Re: 12CBCP024K
210 North 12th Street
Remedial Action Work Plan (RAWP) Stipulation List

Environmental Business Consultants hereby submits a Remedial Action Work Plan (RAWP) Stipulation List for the subject site to the New York City Office of Environmental Remediation (NYCOER) on behalf of ADIR Group LLC. This letter serves as an addendum to the RAWP to stipulate additional content, requirements and procedures that will be followed during the site remediation. The contents of this list are added to the RAWP and will supersede the content in the RAWP where there is a conflict in purpose or intent. The additional requirements/procedures include the following:

Stipulation List

**HOT SPOT EXCAVATION AREA
ENDPOINT SAMPLING LOCATIONS**

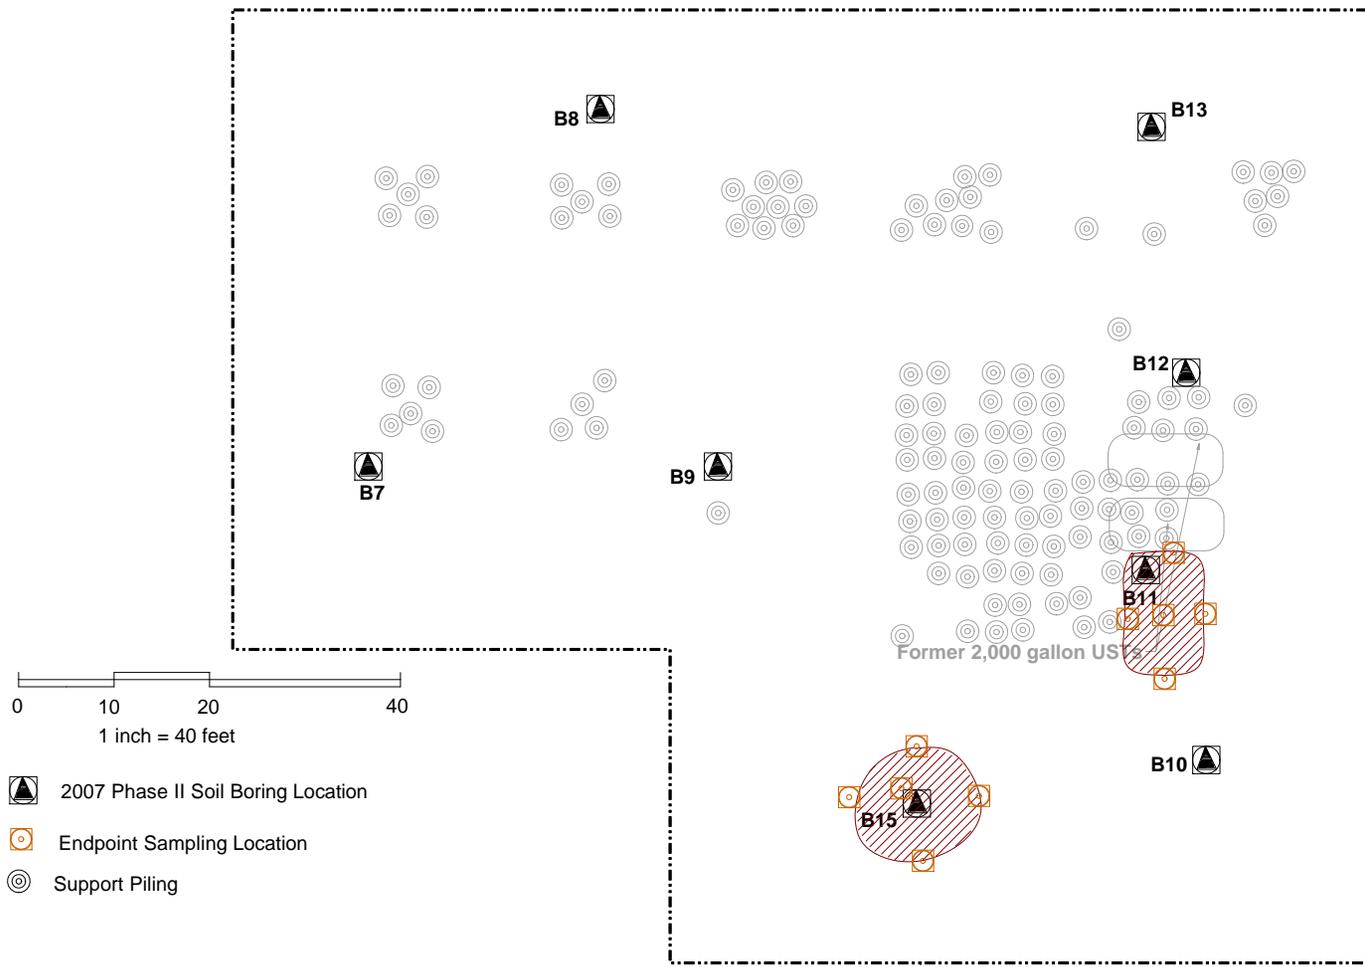
3. Based on the SCOs for the site, two hot spot areas will be removed as shown in Addendum 2.
4. Collection and analysis of End Point Samples will be conducted to evaluate the performance of the remedy with respect to attainment of Track 4 SCOs. End point samples will be taken for parameters of concern. A map indicating post-remedial End Point Sampling Locations is attached as Addendum 2.

AMC ENGINEERING PLLC 99 JERICO TURNPIKE SUITE 300J JERICO, NY 11753 (516) 417-8588	
PROJECT	
210 N. 12th Street, Brooklyn, NY Block 2291 Lot 17	
TITLE:	
FIGURE 5 COMPOSITE SITE COVER	
SEAL & SIGNATURE	DATE: NOV 7, 2011
	PROJECT No:
	DRAWING BY: AC
	CHK BY:
	DWG No: NV-1.00
CADD FILE No: 1 of 3

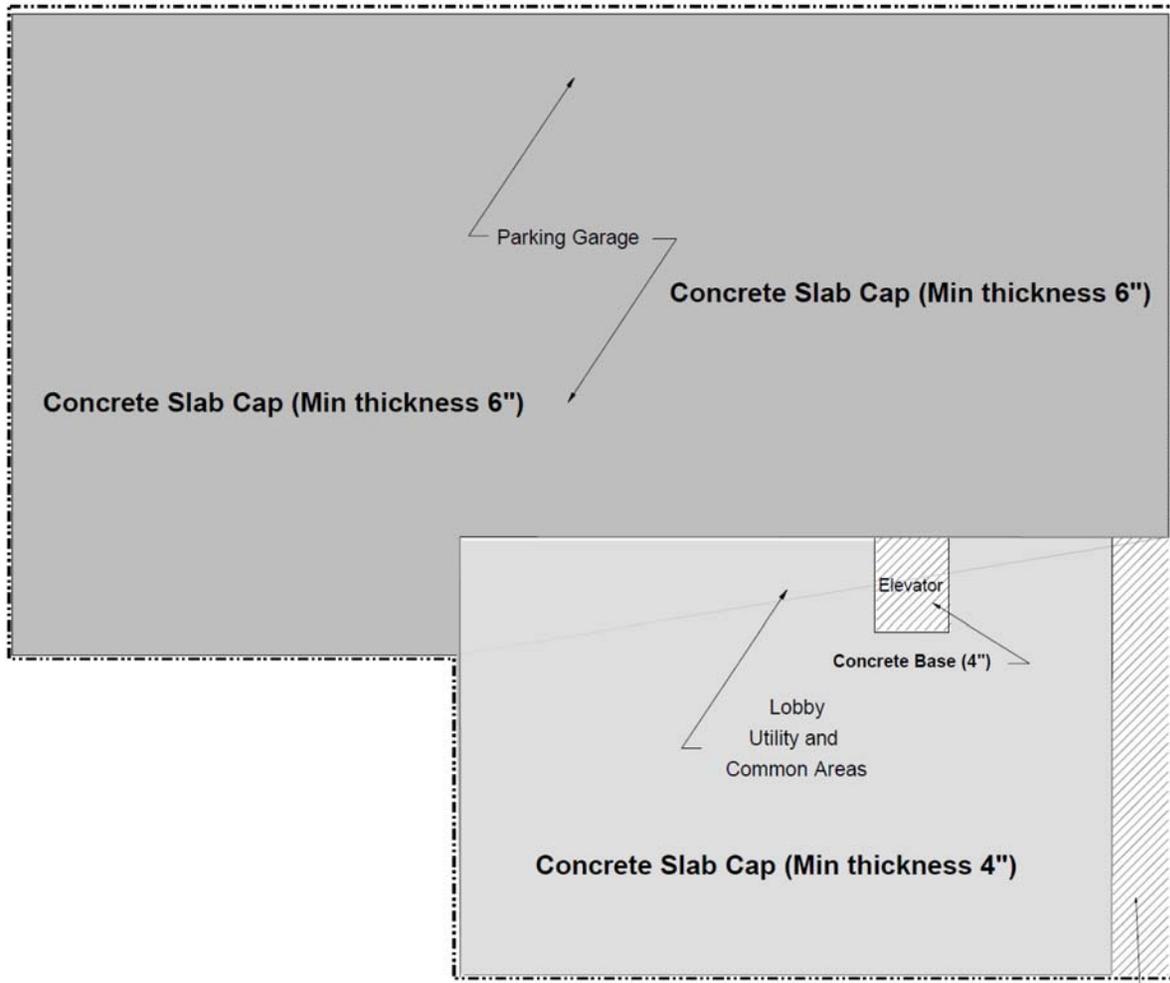
7. Certified, signed, and stamped by PE/ RA of record architectural and engineering plans, including final cover slab design, excavation diagram for footings/development-related excavation, vapor barrier design (cross-section and plan showing horizontal extent), and sub-slab depressurization system design are attached in Addendum 3.

TITLE:
FIGURE 6
SSDS SYSTEM LAYOUT

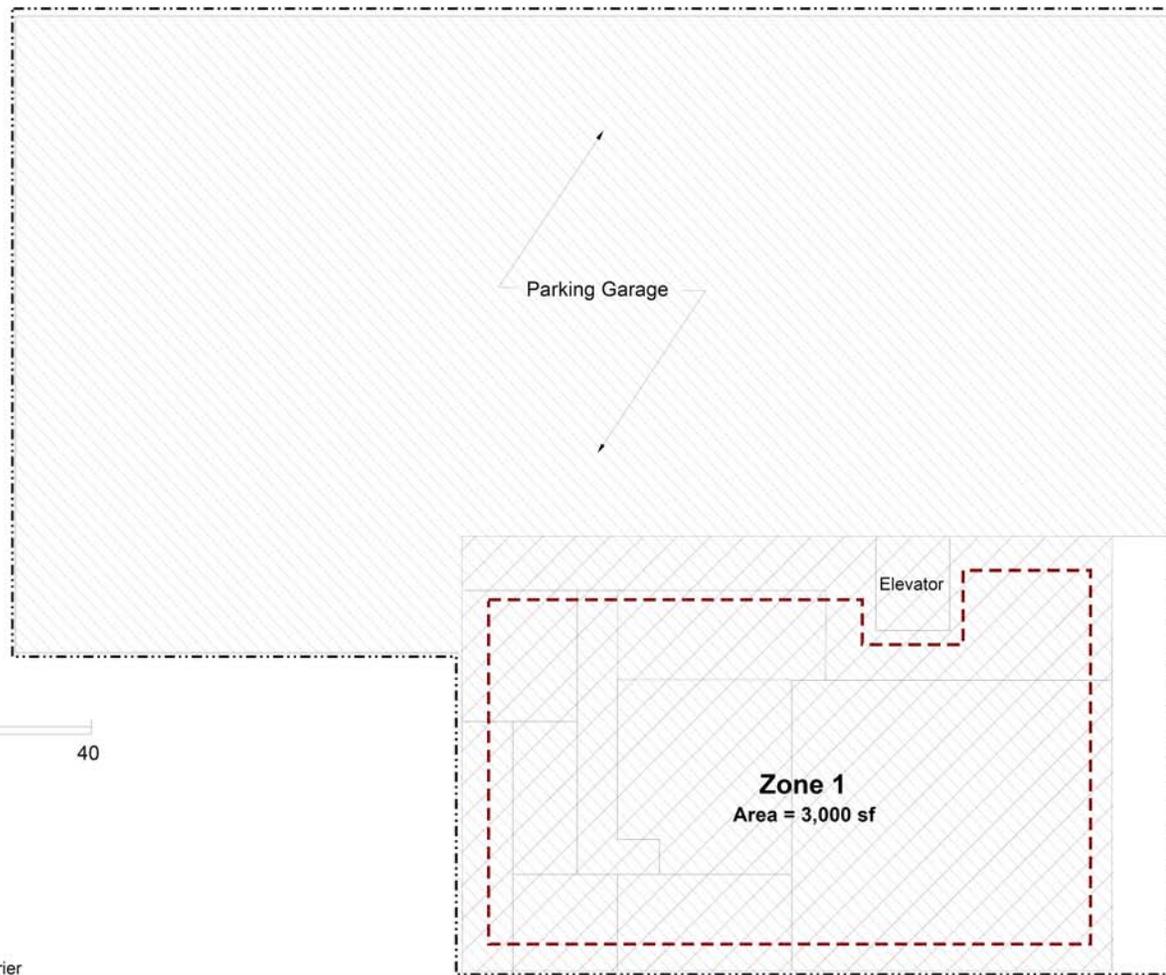
5. The remedy will include installation of a passive sub-slab depressurization system (SSDS) beneath the portion of the building slab where ventilated parking is not proposed.

TITLE:
 FIGURE 7
 SSDS DETAILS

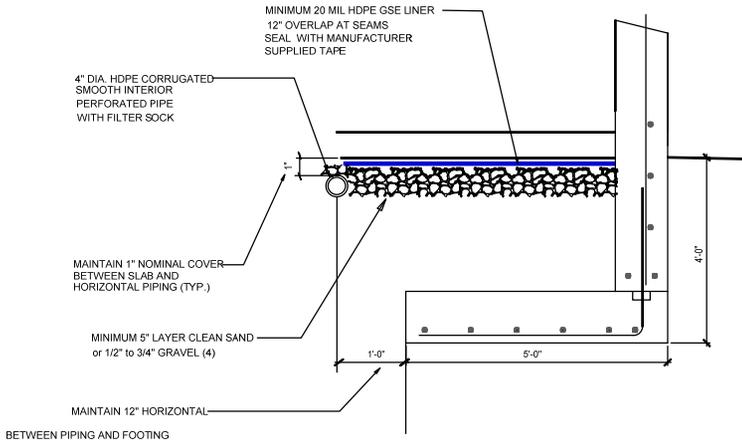
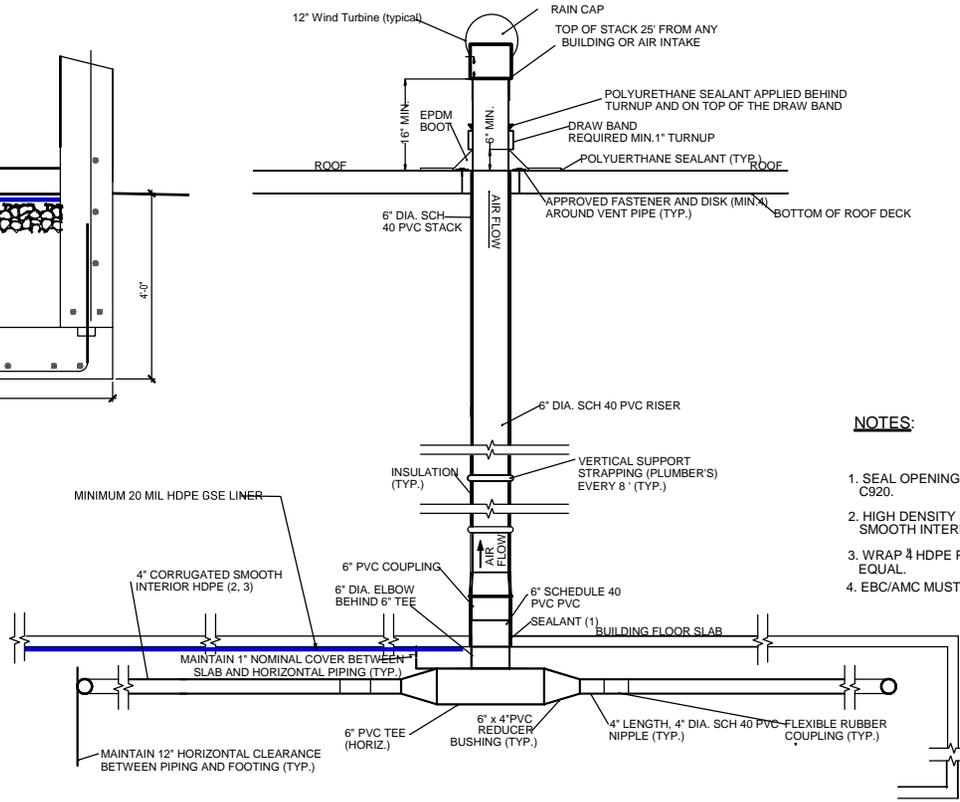
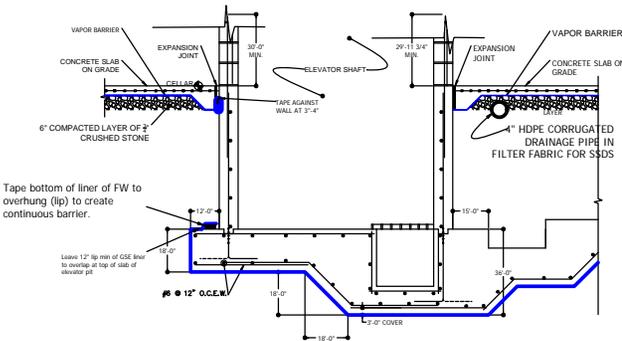
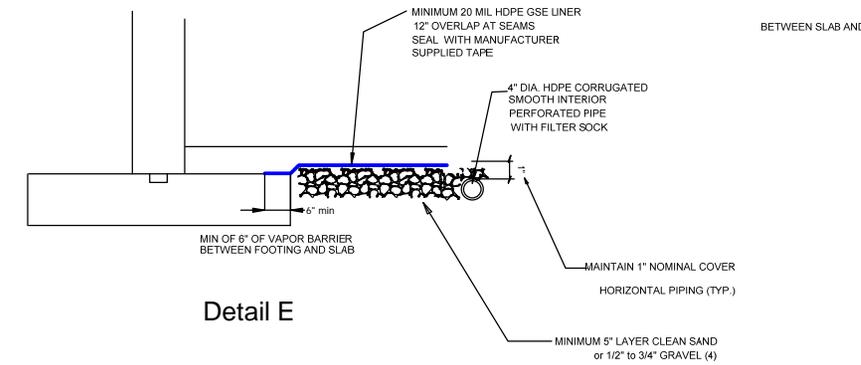
6. The vapor barrier planned for this project is a GDE or equivalent 20 mil barrier to be installed beneath the building slab. This barrier is an impermeable membrane that is capable of preventing the migration of soil vapor into the new building. The vapor barrier membrane will be chemically resistant to the contaminants present at the site and will have a manufacturer's warranty against defects. If the vapor barrier cannot be shown to be chemically resistant to the

contaminants present, or if the warranty cannot be obtained, then either indoor verification testing will be performed in the first floor gymnasium area, or the passive SSDS will be converted to an active SSDS.
